RECALL CAMPAIGN BULLETIN

NTB11-067

VOLUNTARY SAFETY RECALL CAMPAIGN 2011 – 2012 ALTIMA FRONT TRANSVERSE LINK BOLTS

CAMPAIGN ID #: PC099

Figure 1

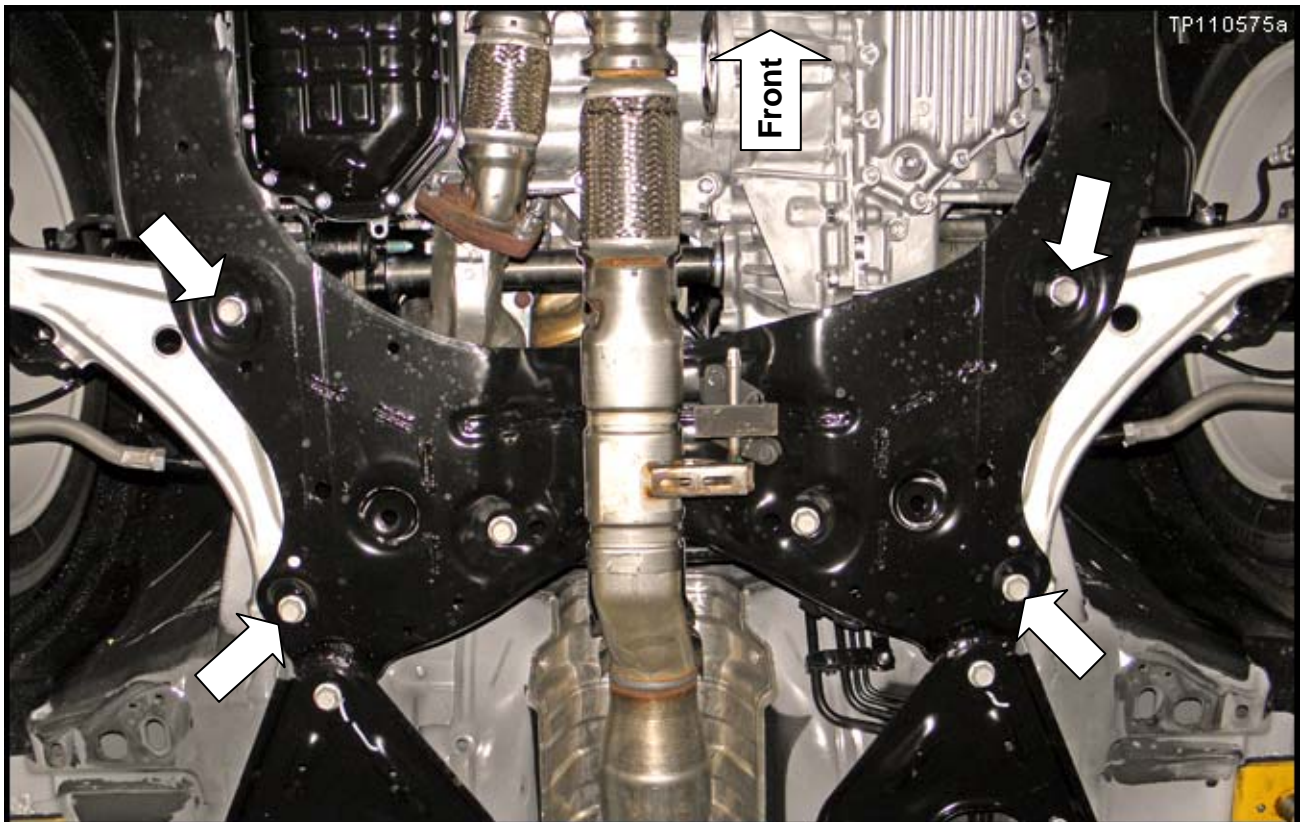
1. Lift the vehicle on a hoist.
2. Locate the front transverse link bolts (see Figure 1).

Figure 2

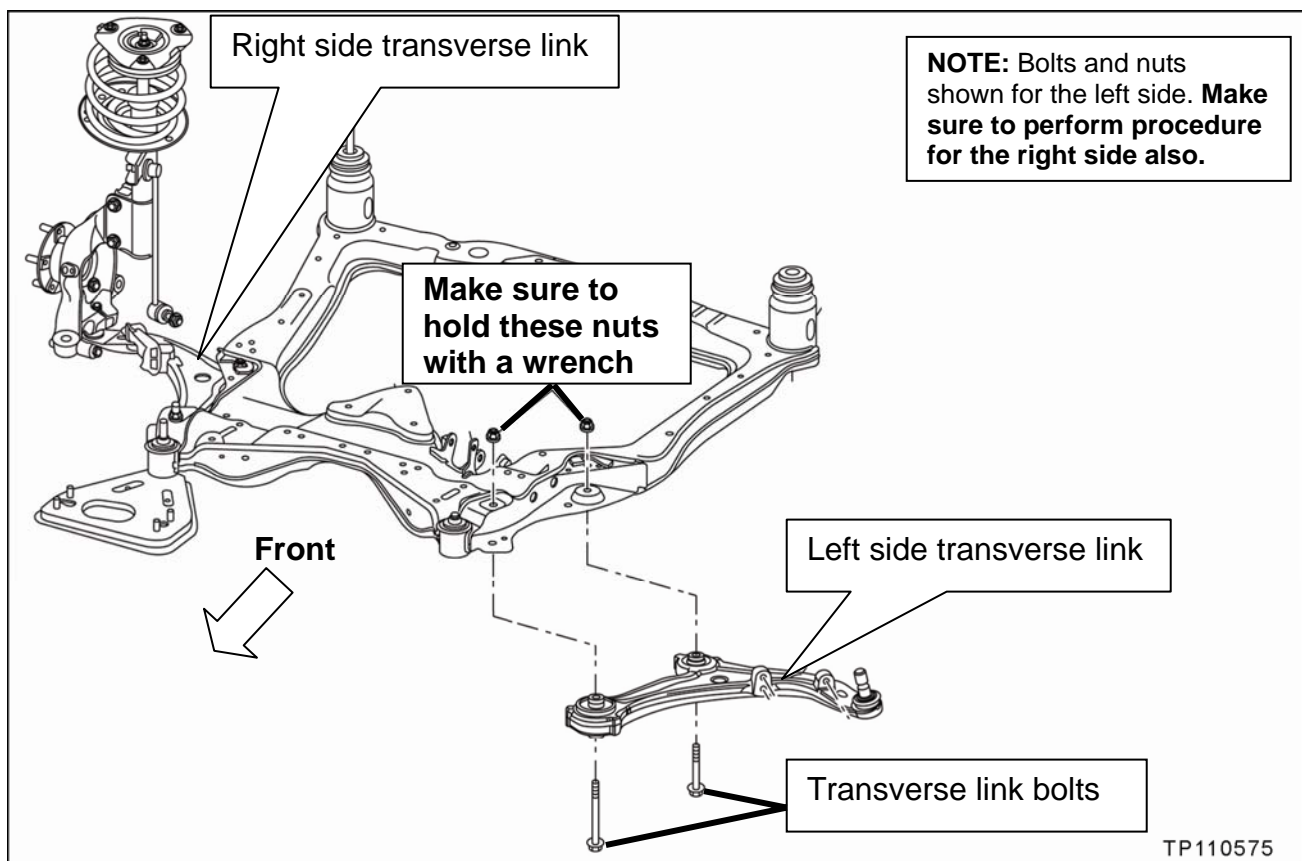
- a. Loosen the 4 transverse link bolts $\frac{1}{4}$ to $\frac{1}{2}$ turn.
- b. Re-torque the bolts to 145 N•m (15.0 kg-m, **107 ft-lb**).
 - **Make sure to use a wrench to hold the nuts (see Figure 2).**

- a. Remove and replace the 4 transverse link bolts and nuts.
- b. Torque the bolts to 145 N•m (15.0 kg-m, **107 ft-lb**).
 - **Make sure to use a wrench to hold the nuts (see Figure 2).**
